# RENESAS TECHNICAL UPDATE

Product Category	MPU&MCU	Document No.	TN-SH7-A685A/E	Rev.	1.00
Title	Note on Use of SH7780 SIOF Slave Mode Receiver	Information Category	Technical Notification		
Applicable Product	SH7780 Group	Lot No.	Reference Document	SH7780 Hardware Manual Rev.1.00 Dec.13.2005 (REJ09B0158-0100)	
		All lots

Figure. SIOF Receive Data Sampling Timing in Slave Mode

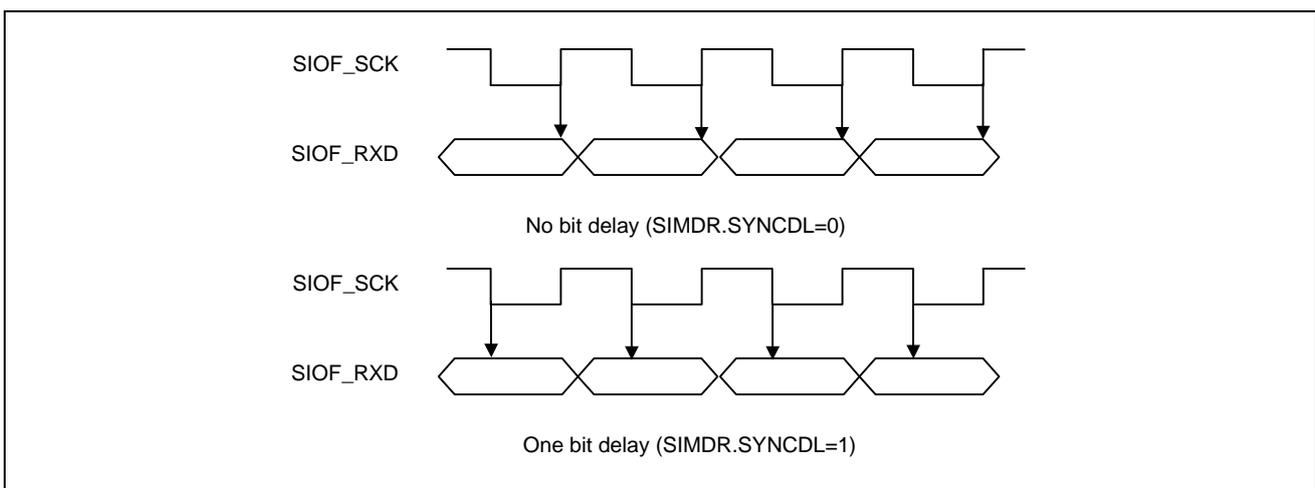
When using the receiver of the SIOF in slave mode, if specifying no bit delay (SIMDR.SYNCDL=0), the receive data is sampled at the rising edge of the SIOF\_SCK, then the hold time of the receive data may not be ensured.

Specify one bit delay (SIMDR.SYNCDL=1) for receiver like for transceiver in slave mode. Then the receive data is sampled at the falling edge of the SIOF\_SCK.
